EAST RIDING OF YORKSHIRE COUNCIL

Local Impact Report

LPA Reference Number: 24/01321/NSIP

Application for a Development Consent Order (DCO) for the construction, operation (including maintenance) and decommissioning of ground mounted solar photovoltaic (PV) panel arrays with approximate generating capacity of 400 MW. The Scheme includes underground cabling to connect to the national electricity transmission network at National Grid's Drax Substation; underground cabling between the areas of solar PV panels; areas of landscaping and biodiversity enhancement; and other associated development.

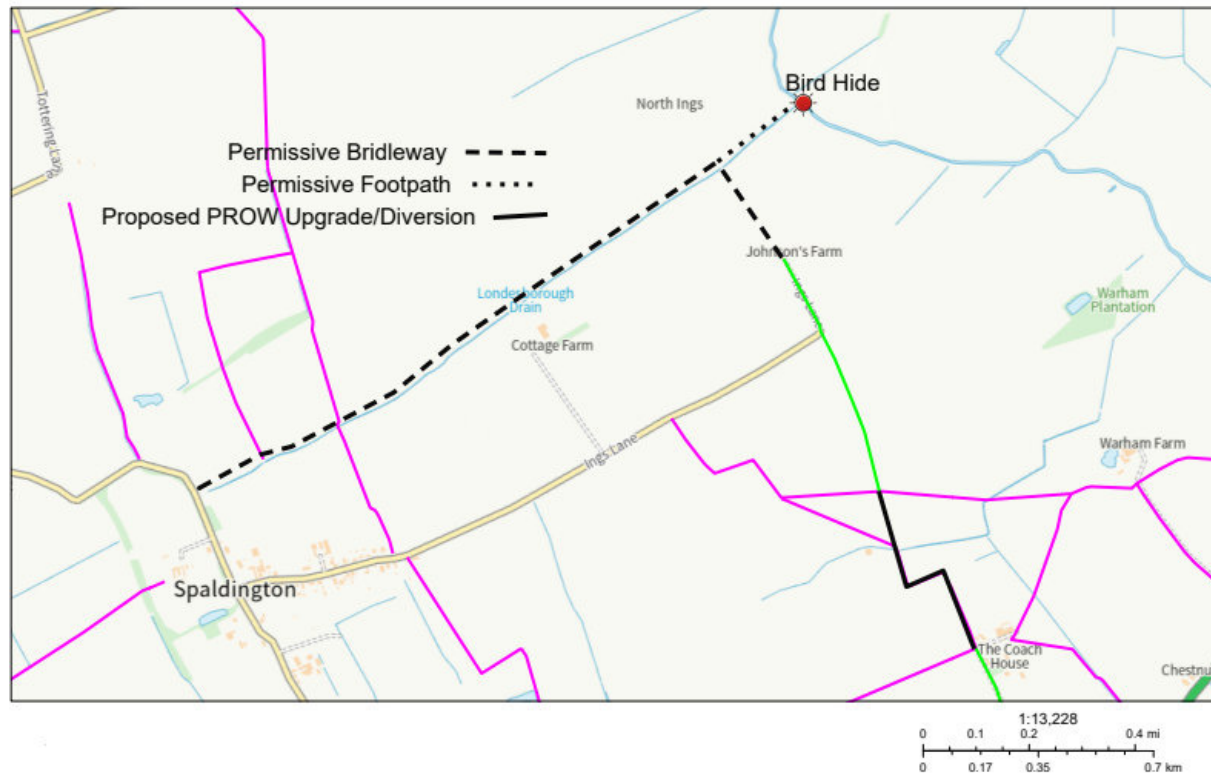
Although the inclusion of permissive routes is positive, officers do not feel the status or extent of these routes has been carefully considered, nor does it correspond with initial discussions that PROW officers had with the applicant.

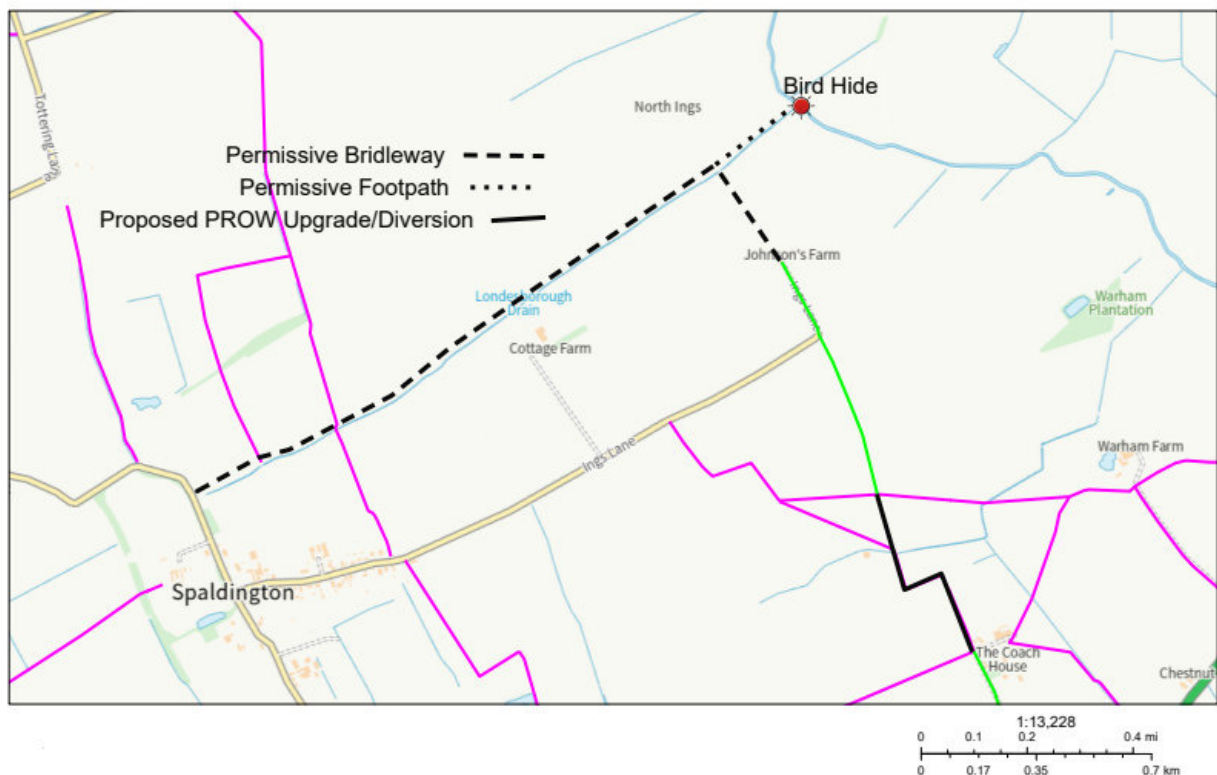
- I have to reiterate the comments of the Countryside Access Team in relation to what you propose as ‘managed’ and that the PROW’s cannot be altered without a Temporary Closure/Diversion Order or a Definitive Map Modification Order. Expansion on detail will be required.
- Should any decision be made to make any of the ‘Temporary’ closure/diversion of routes permanent it is imperative that contact is made to the Definitive Map Team as soon as possible.
- As part of the authority’s Rights of Way Improvement Plan we encourage enhancement to the PROW network through development. This would be a perfect opportunity to make those permissive paths and upgrade permanent. Please contact the Definitive Map Team if more information is required on this. See plan below for location of these routes.
